WICA Audit Report to IPART

Licence No. 10_008: Veolia (Darling Walk) Non Potable Water Scheme

Licence Plan Audit (Recycled Water Quality Plan)

Document Version 5, prepared 28 July 2019

Figure 3. UV disinfection system plate.

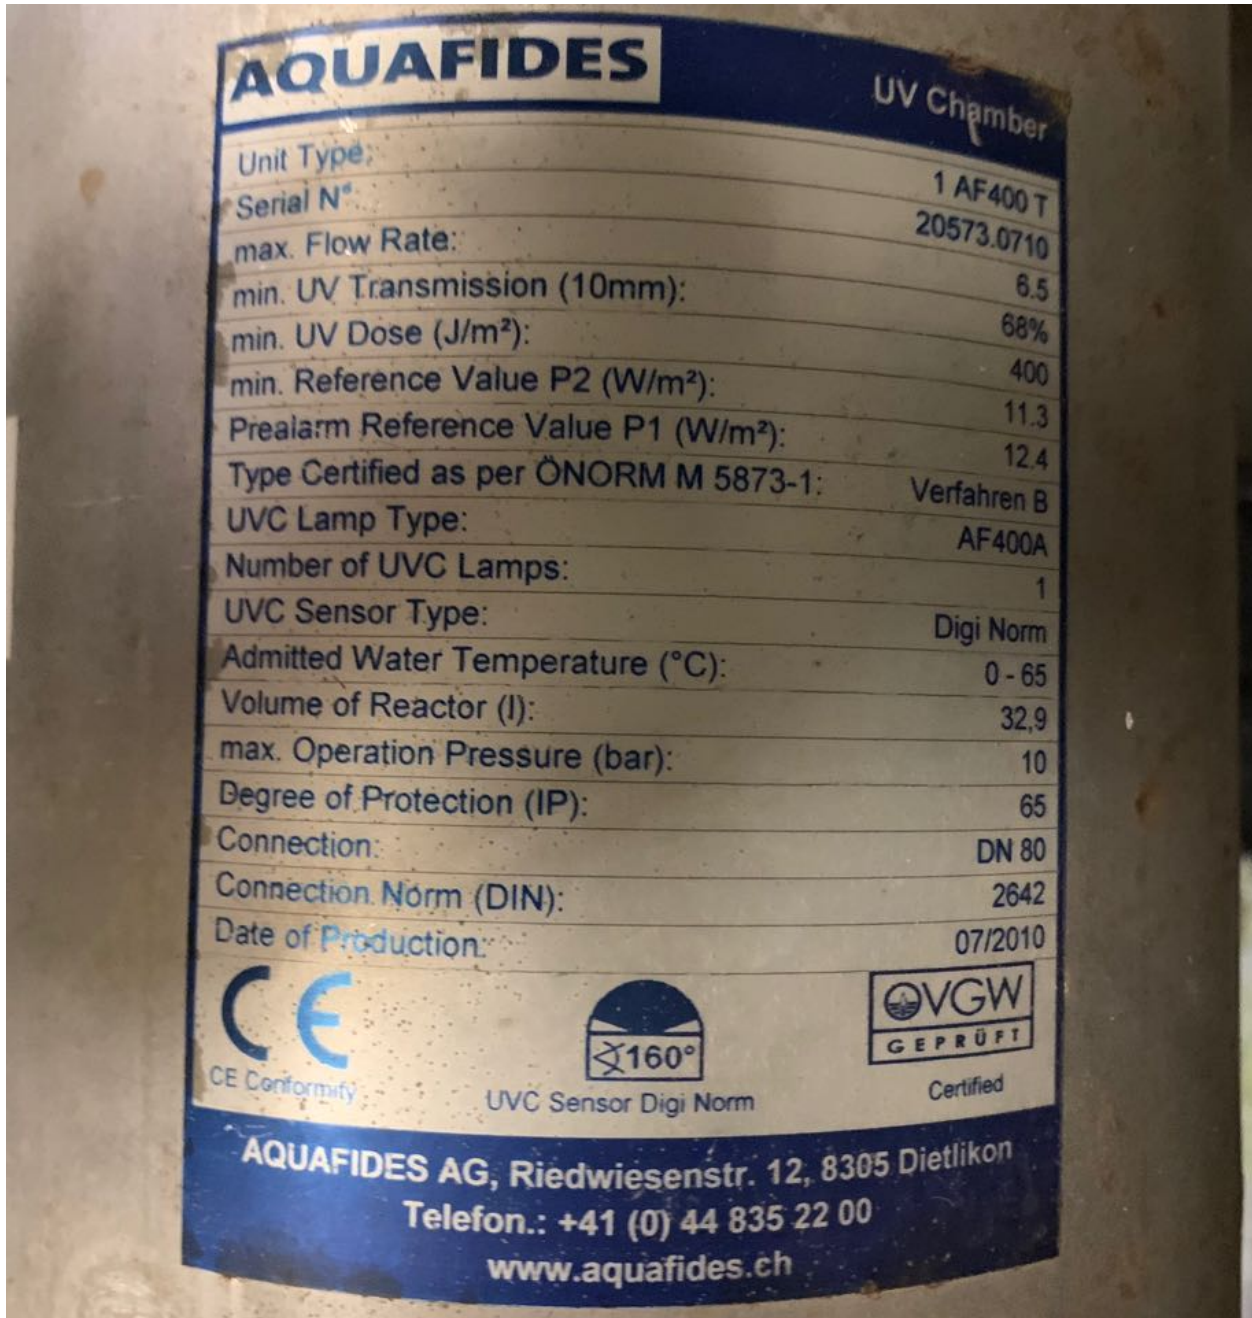
- The validated Aquafides 1AF400T UV disinfection system was found by the operator to be validated to provide a dose of > 40 mJ/cm² for a stated UVT of ≥ 80%. However, the name plate on the reactor showed a minimum UVT of 68% (Figure 3). In practice the performance has been higher, of the order 99%, given the RO process. Nonetheless, some explanation of how VWST will remain confident that it knows what the critical lower limiting UVT is, either 68% or 80%, and that the UVT is not below that limit, and that the flow rate will not exceed the upper limit within which the validation is warranted. This information is not provided in the *Water Quality Plan*, any document cited in the *Water Quality Plan*, nor the *Validation Plan*.

- the specific lower limiting UVT needs to be documented and cited; and
 - a detailed explanation of why online UVT monitoring is not required should be added to justify not having a UVT measurement online to ensure that the UV disinfection system is operating within its validated UVT range.
